Adequacy Review Report

Project Assessment 2014-0002

Casino Mining Corporation Casino Mine

January 27, 2015

Figure 1: Cross-section of TMF main embankment showing the dam core

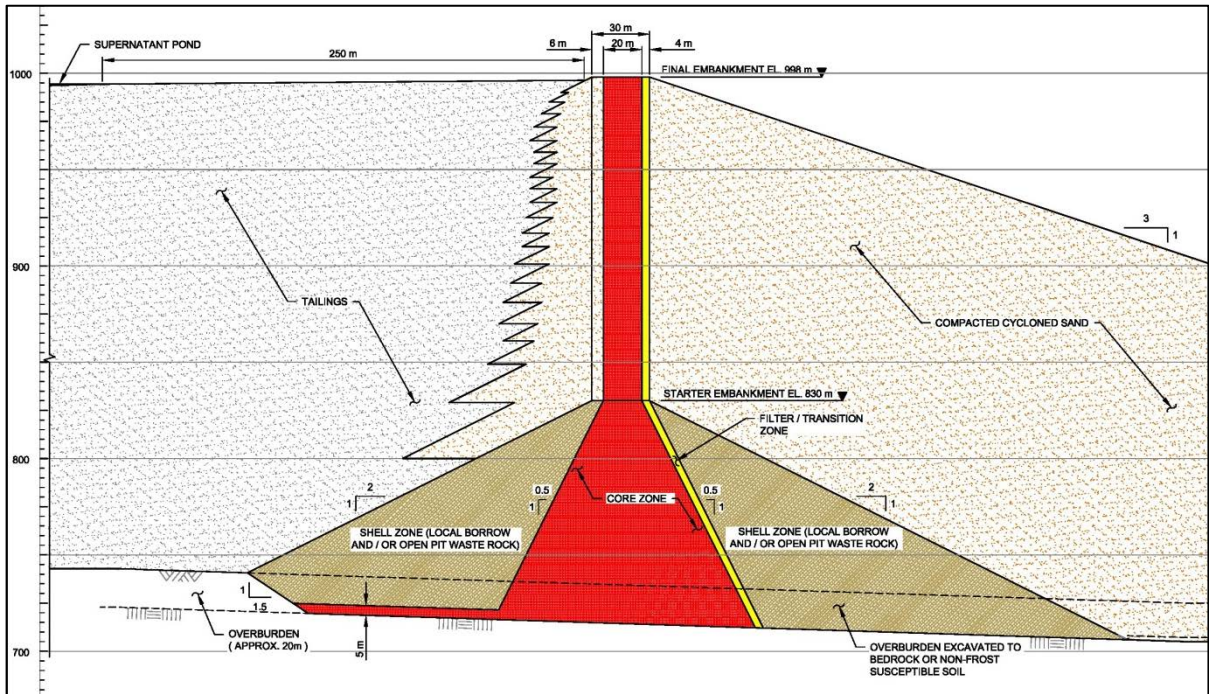
The TMF main embankment core is proposed to be a uniform thickness of 20 m from 830 m asl to the crest of the dam at 998 m asl (Figure 1). Downstream from the dam core is a 4 m wide filter zone to move any seepage from the core through the embankment.

The Executive Committee requires further information regarding the design of the TMF in relation to core width. Therefore, please provide the following:

- R82. Rationale for the proposed thickness of the core and downstream filter, considering the dam height and permanent performance requirements.

Figure 2: Conceptual design for the winter seepage mitigation pond

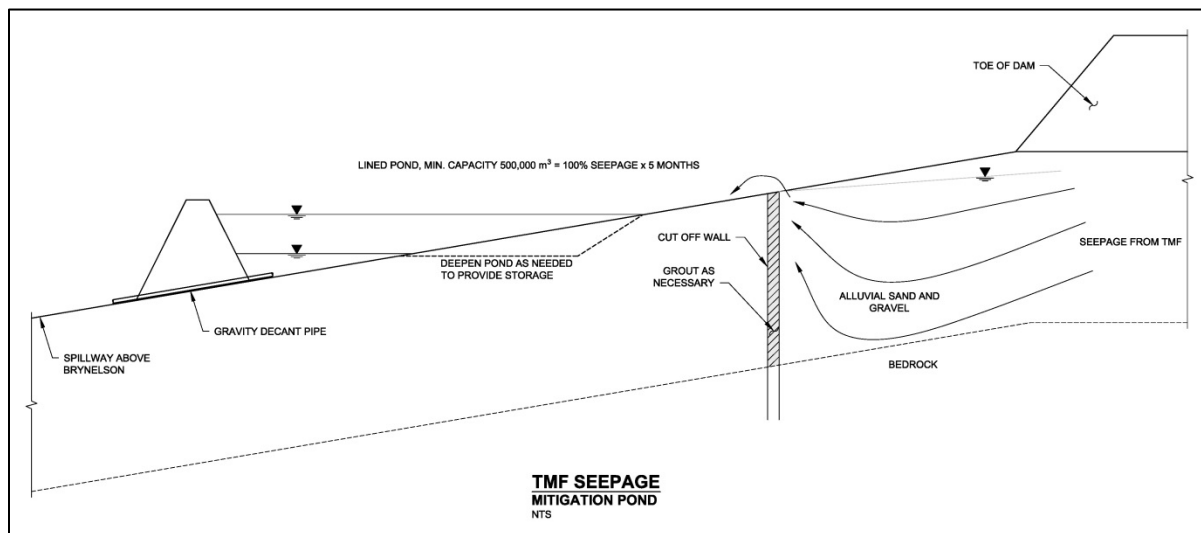
EcoMetrix raises concern that the WSMP does not include a description of the cut-off barrier construction considering its placement in both overburden and bedrock (Figure 3.5-1 in YOR 2014-0002-126-2). Furthermore, there are limited details on the nature of the overburden and bedrock. These details are important to understand the effectiveness of the WSMP in capturing seepage from the tailings management facility.

Furthermore, the conceptual closure and reclamation plan (CCRP) provides a general overview of the WSMP including the requirement for an approximately 10 m high earthen dam. Few details are provided about this dam beyond capacity requirements. Information on this dam is essential to understanding potential effects and risks from the WSMP pond that will contain contaminated TMF seepage.

Figure 3: Water quality baseline sampling locations

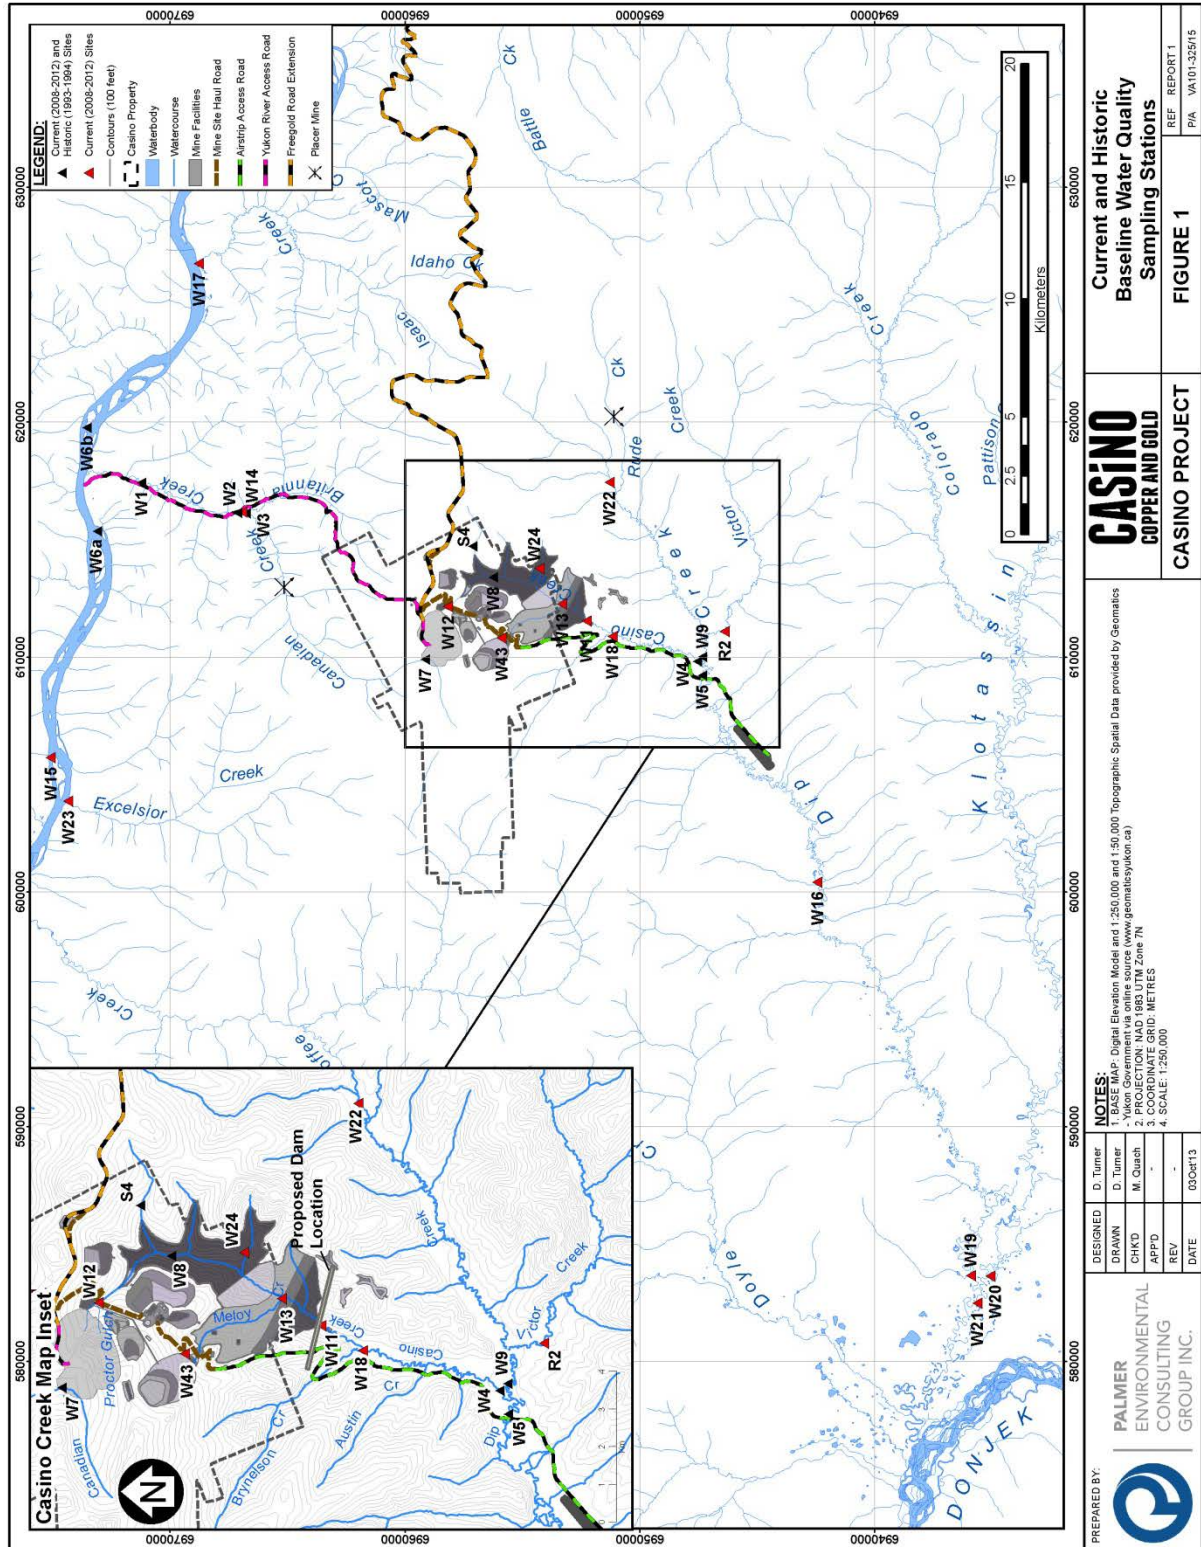
Section 4.1.1 of Appendix 7A speaks to reasonable variability and seasonal sampling efforts conducted by the proponent. In addition, Table 2 summarizes the number of samples for each sampling station by date. YESAB's *Proponents Guide: Water Information Requirements for Quartz Mining Project Proposals* directs proponents to "[p]rovide measurements of water quality parameters relevant to the project on a minimum monthly basis for a minimum period of one year to estimate seasonal variability" (YESAB, 2011, p. 9). In addition, this guide suggests proponents consider multi-year sampling and conduct sensitivity/uncertainty analysis in order to estimate inter-annual variability.

CMC made an effort to obtain monthly samples for a period of one year between August 2009 and October 2010. While 23 stations were actively sampled during this period, only two stations (W3 on Canadian Creek and W9 on Dip Creek) were sampled over consecutive months during this period. Although not continuous, samples were collected for each month at four stations (R2 on Victor Creek, W20 and W21 on Klotassin River, and W15 on the Yukon River) between 2008 and 2012. Most of the remaining stations have incomplete full calendar monthly datasets.

Figure 4: TMF conceptual model flux pathways

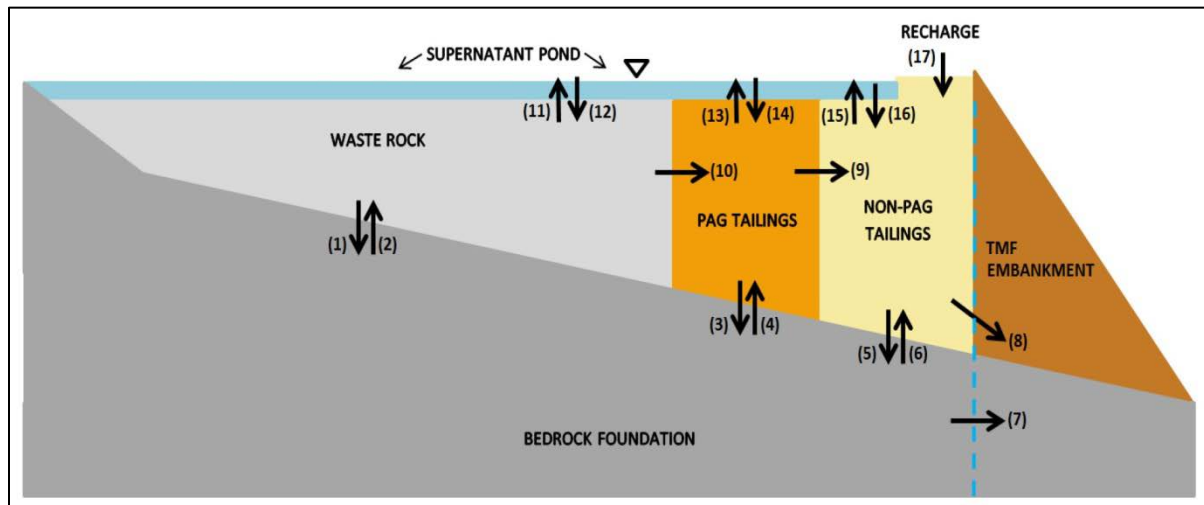
In developing the source terms and water quality model, CMC conducted a seepage assessment for the TMF using the mine effects model. This seepage assessment was summarized in Appendix 7E, Numerical Groundwater Modeling (CMC, Casino Mining Corp, 2014). CMC provides a conceptual diagram of the TMF sub-components and seepage flows as reproduced in Figure 4 below.

- R237. An explanation of how loadings from embankment runoff and embankment seepage relate to the conceptual flow diagram in Figure 7-2 in LORAX (2013) Casino Geochemical Source Term Development, 4 December, J862-5. In addition, please confirm that those loadings were included in the water quality model.

Figure 5: Fish and aquatic resources sampling sites

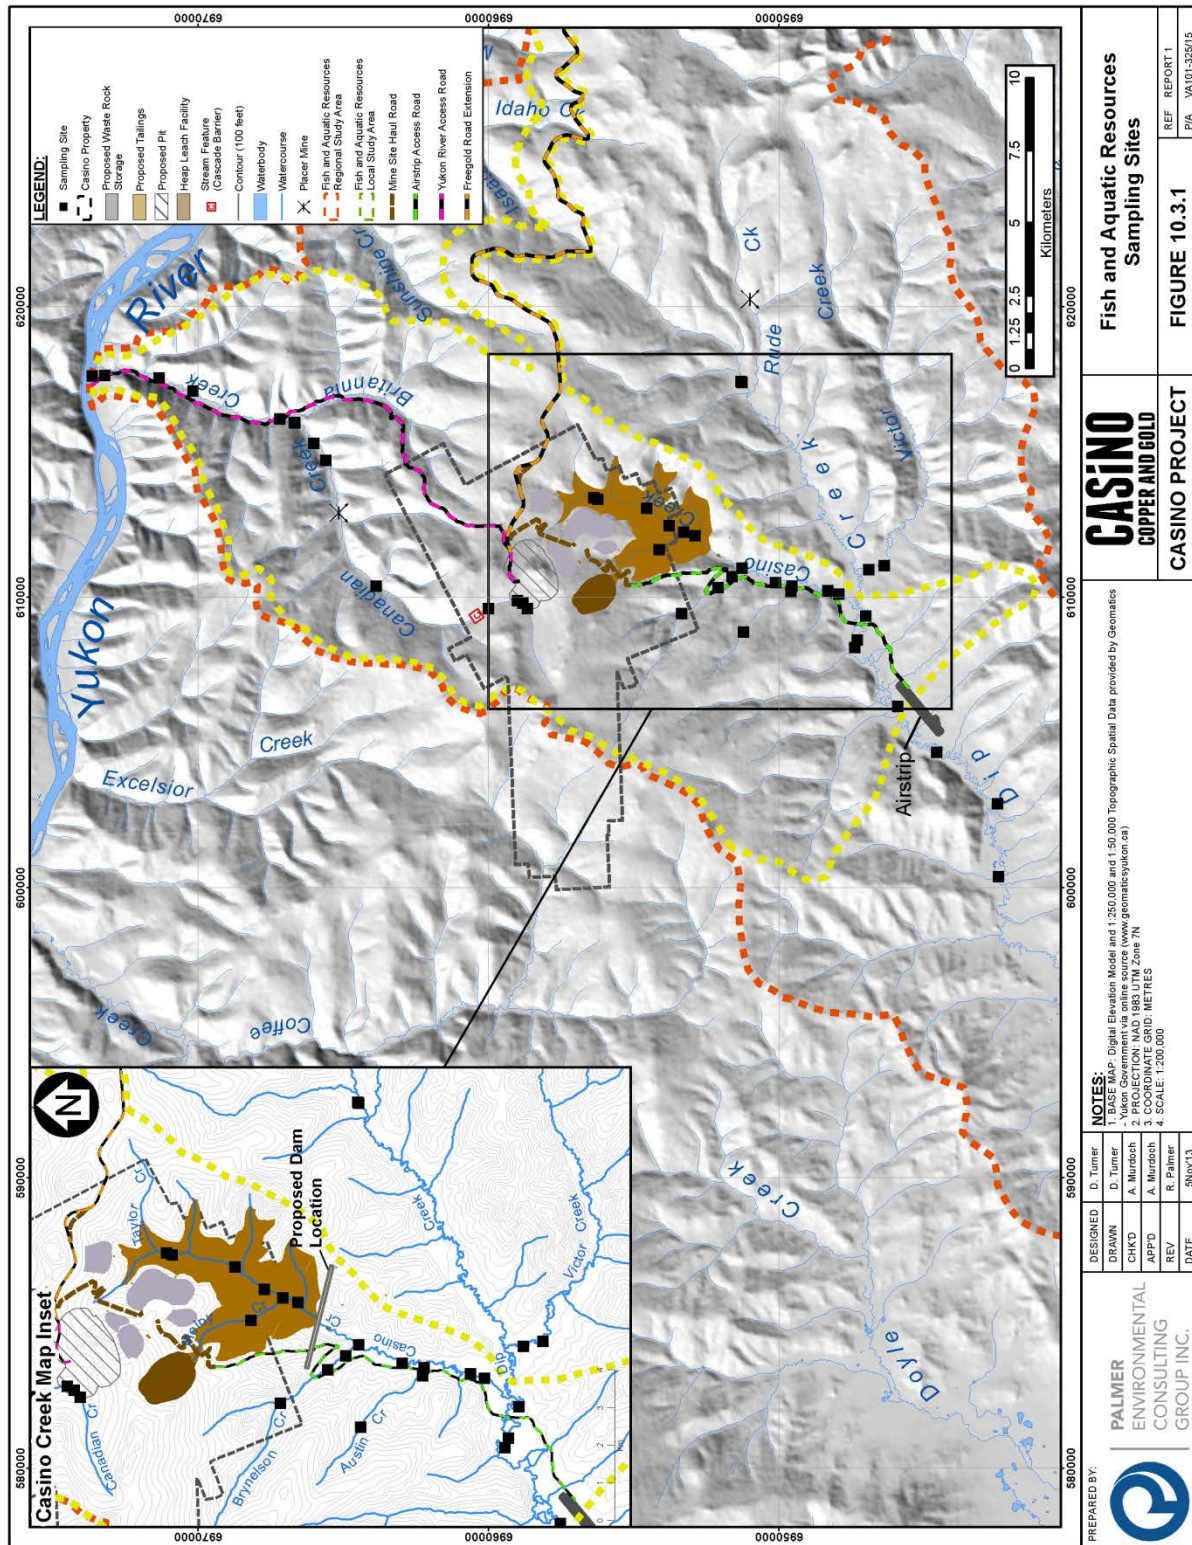
The LSA used for the collection of baseline data does not include all fish and aquatic resources potentially affected by the Project. It does not include downstream water bodies, the airstrip, or the portion of the unnamed creek affected by the construction of the airstrip as shown in the Figure 4.3 from Appendix 10C of the proposal.
